DEPARTMENT OF THE ARMY Omaha District, Corps of Engineers 106 South 15th Street Omaha, Nebraska 68102-1618

Amendment No. 0001 20 June 2002

SUBJECT: Amendment No. 0001 to Specifications and Drawings for Construction of South Platte River Visitor Center Rehab, Chatfield Project, Littleton, CO.

Solicitation No. DACA45 02 B 0016.

Sheet AC.01 Am #0001

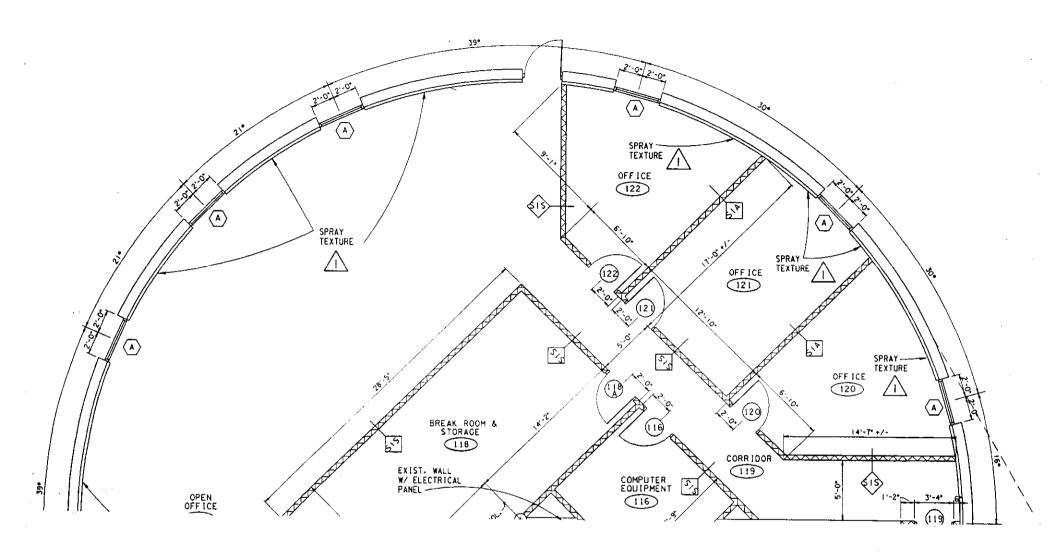
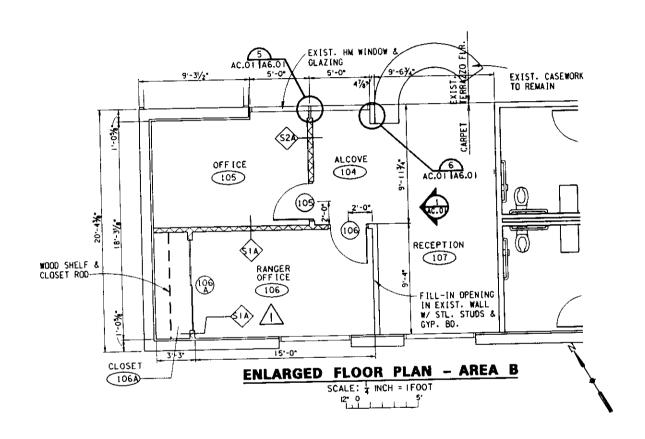
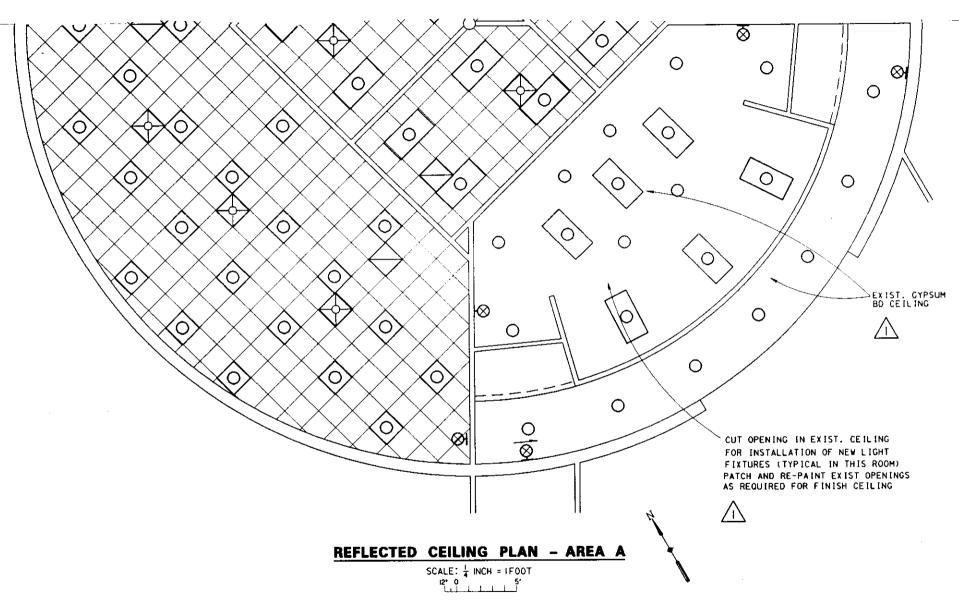
- (2) Sheet AC.01, revise Enlarged Floor Plan Area A as shown on the attached partial sheets. (2 Sheets)
- (3) Sheet AC.01, revise Enlarged Floor Plan Area B as shown on the attached partial sheet.

Sheet A4.01 Am #0001

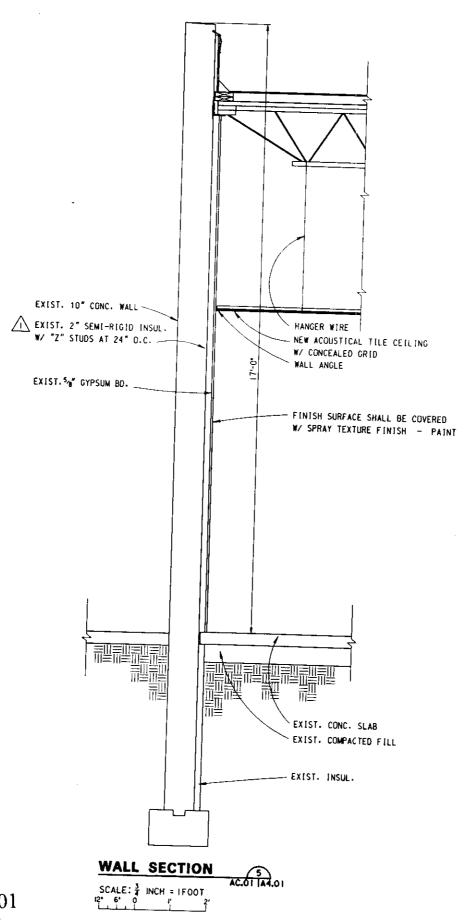
- (4) Sheet A2.01 , revise Reflected Ceiling Plan Area A as shown on the attached partial sheet.
- (5) Sheet A4.01, revise Wall Section, Detail 5, as shown on the attached partial sheet.

Sheet A6.01 Am #0001

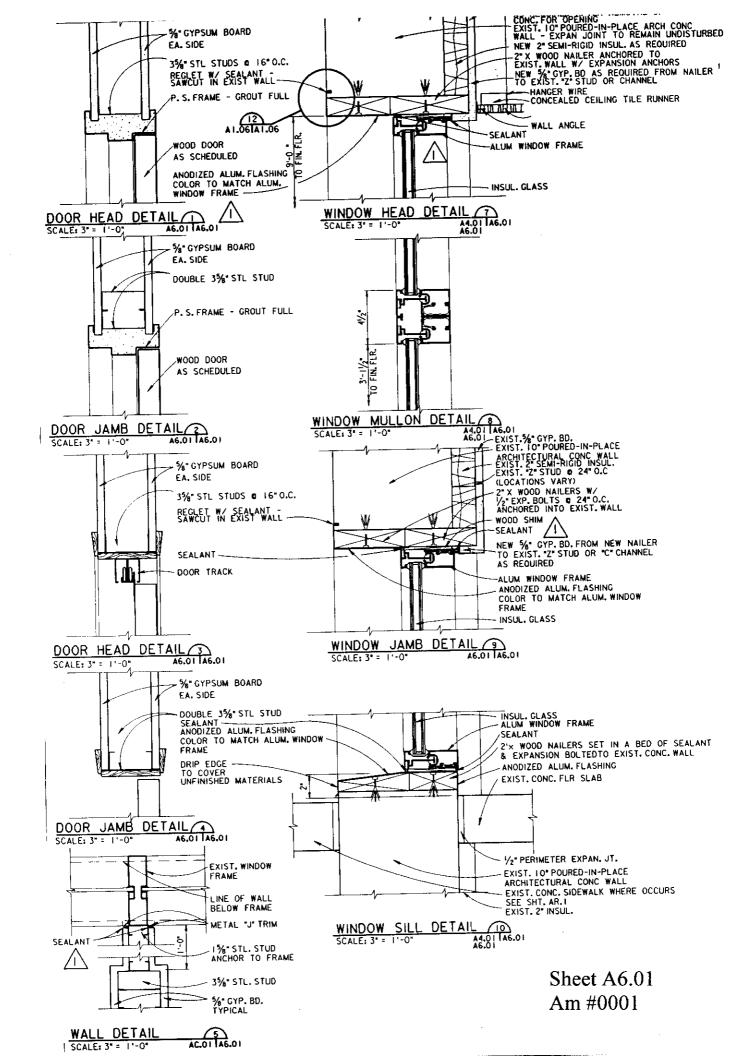
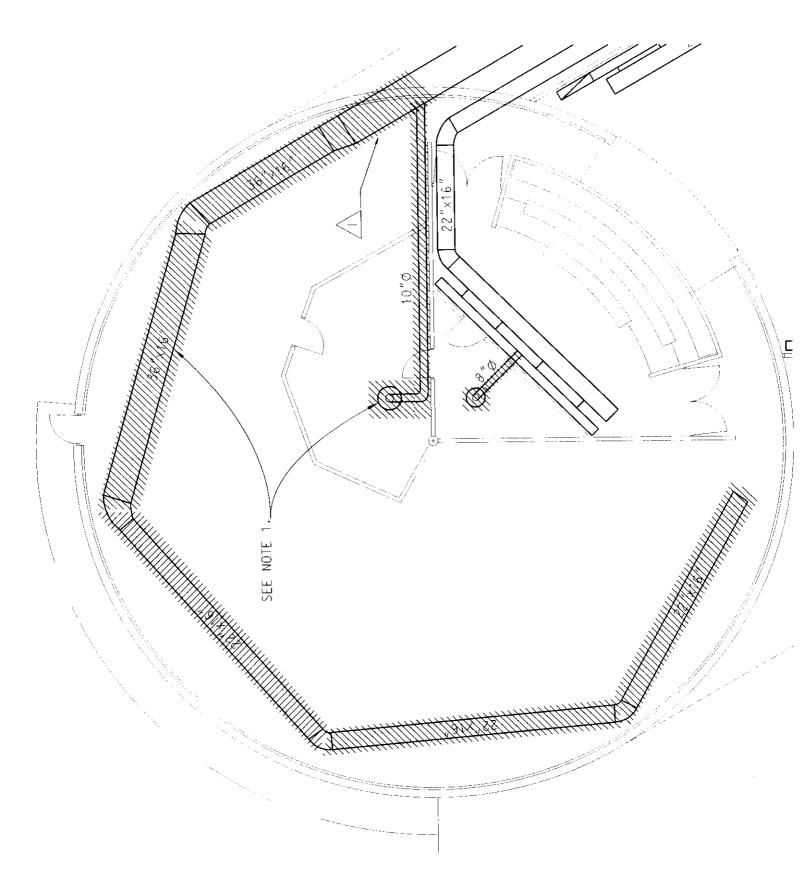
- (6) Sheet A6.01, revise Room Material and Finish Schedule as shown on the attached partial sheet.
- $\mbox{(7)} \quad \underline{\mbox{Sheet A6.01}}, \; \mbox{revise the Door and Window details as shown on the attached partial sheet.}$
